Wollongong Local Planning Panel Assessment Report | 16 October 2019

WLPP No.	Item No. 3
DA No.	DA-2019/595
Proposal	Residential - demolition of existing building and tree removals. Construction of multi-unit housing comprising of four (4) dwellings with one (1) level of basement carparking
Property	28 George Street, THIRROUL NSW 2515 Lot 28 DP 1099628
Applicant	Mr Marko Lisica
Responsible Team	Development Assessment & Certification – City Wide Planning Team (MB)

ASSESSMENT REPORT AND RECOMMENDATION

Ground Floor Unit 3 and 4

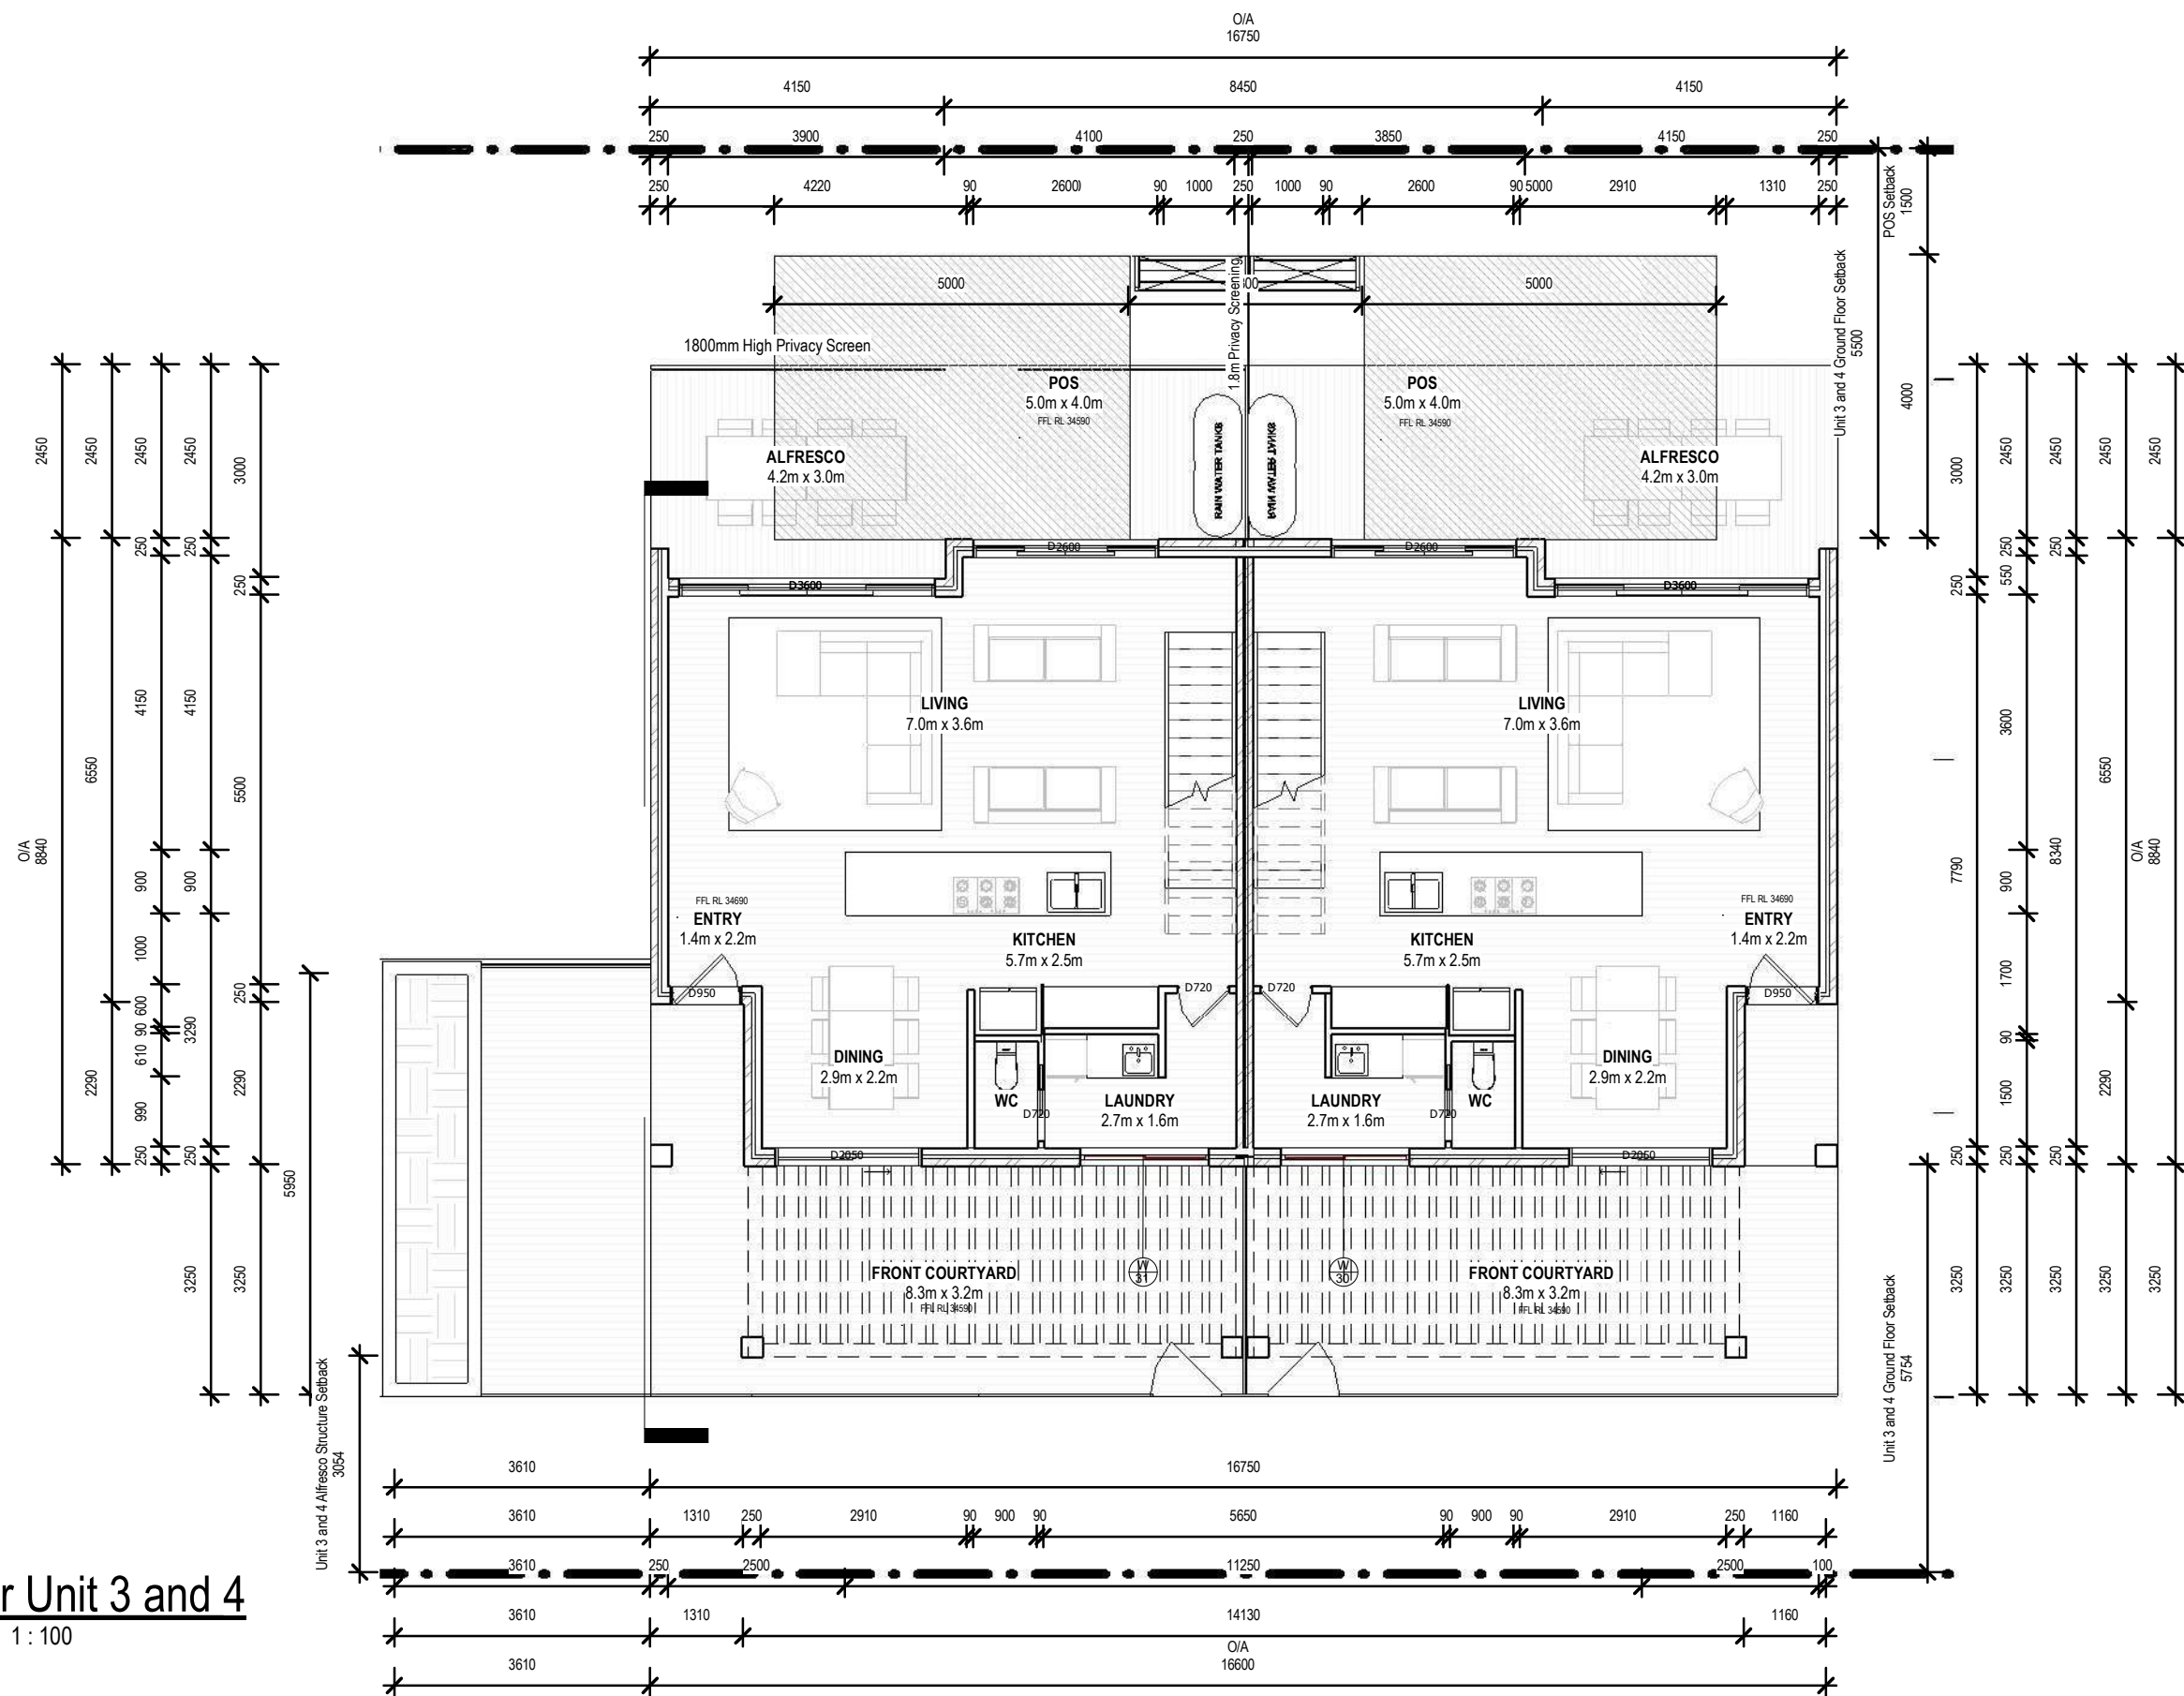
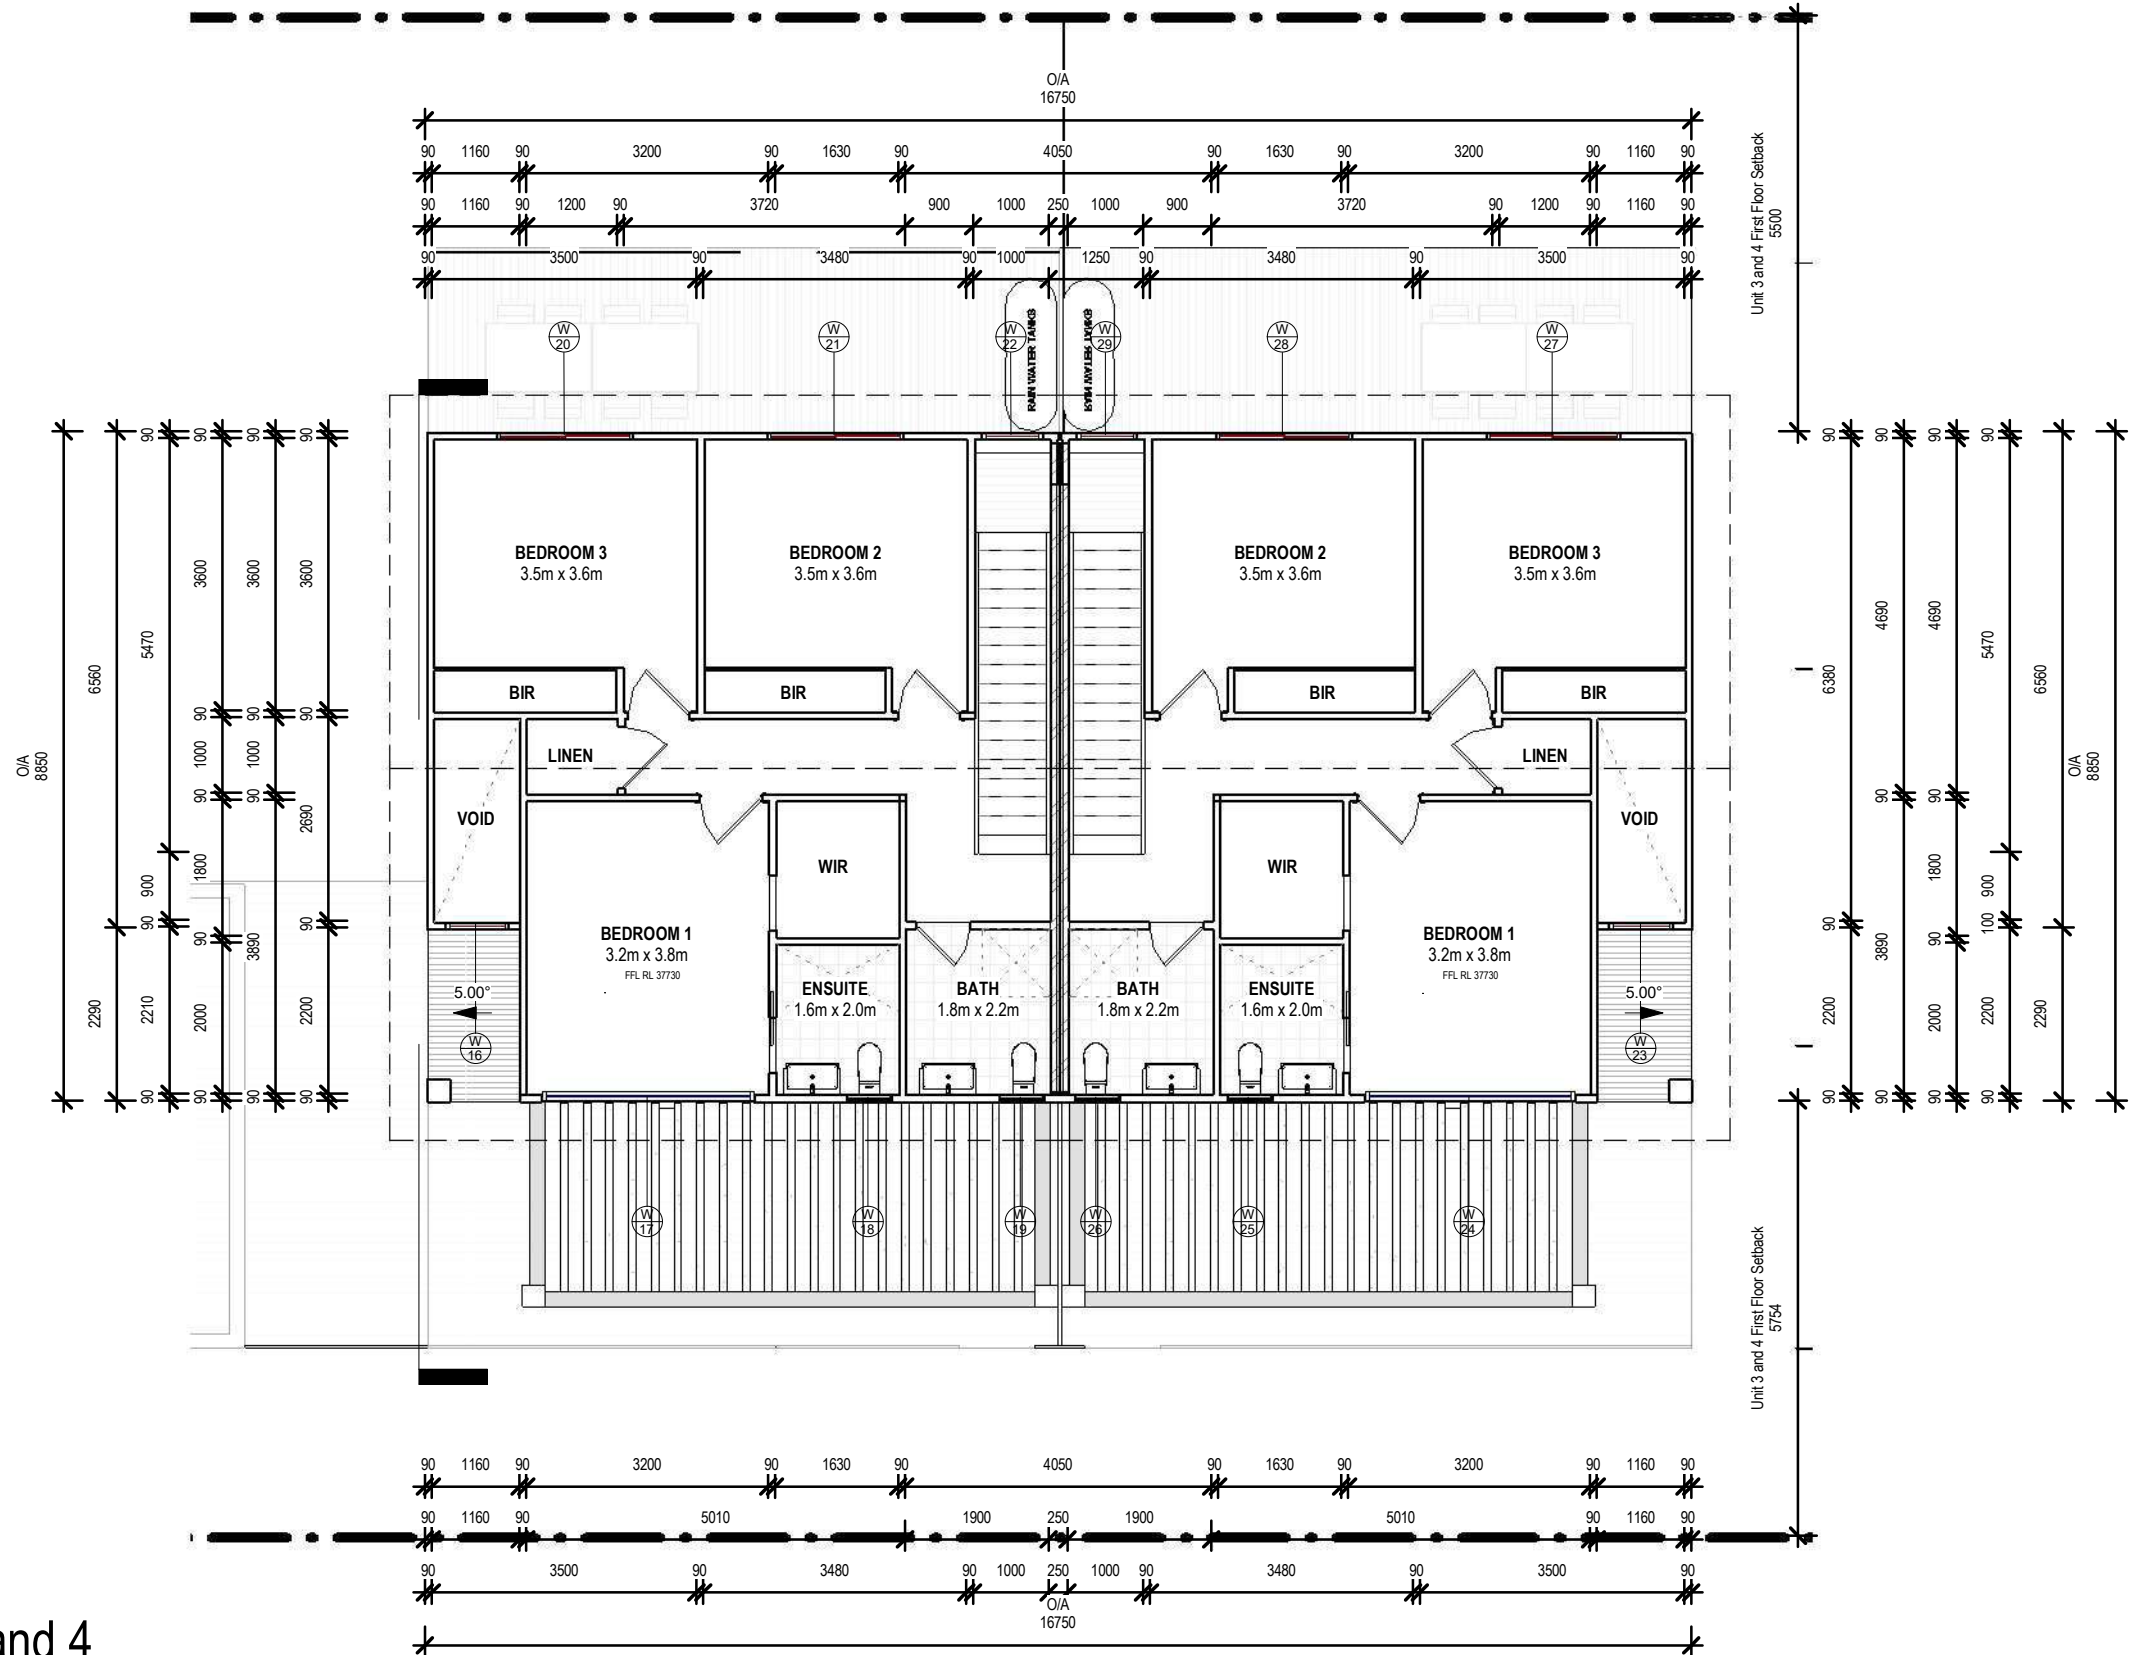
Units 1 and 3 both have areas of the POS and the front courtyard elevated (one metre) above natural ground level (at the southernmost end) which is considered to pose potential overlooking impacts to adjoining properties on both the eastern boundary and the western boundary. A 1.8m high privacy screen (horizontal angled slats to provide sunlight penetration) has been proposed on the western side of the elevated private open space to ensure view lines are directed away from the neighbouring property to the west. A terrace/courtyard is proposed on the eastern side of both Units 1 and 3. The courtyard includes a pergola and neighbouring trees do provide screening;

however, it is considered that the extent of the terrace particularly for Unit 3, which is larger could be minimised or lowered. This matter is outlined at **Attachment 3**.

A 1.8m high privacy screen (horizontal angled slats to provide sunlight penetration) has been proposed along the private open space on the western boundary for both units. In this case, it is not considered that a privacy screen is adequate to mitigate potential impacts and design changes are required. This could be achieved by:

A terrace/courtyard is also proposed on the eastern side of both Units 1 and 3. The courtyard is partially covered with a pergola and trees on the neighbouring property will provide screening at this point in time; however, it is considered that the extent of the terrace particularly for Unit 3 should be minimised or lowered. This could be achieved by:

- Reducing the size of the front courtyard at the southern end to create a screened walkway for Unit 3 and,
- Removal of access to the parapet from Dwelling 3 or the extension of the planter box to remove the ability for overlooking from the parapet **or**,
- Removal of the proposed front courtyard to Units 1 and 3

Amended plans should be provided addressing the above.
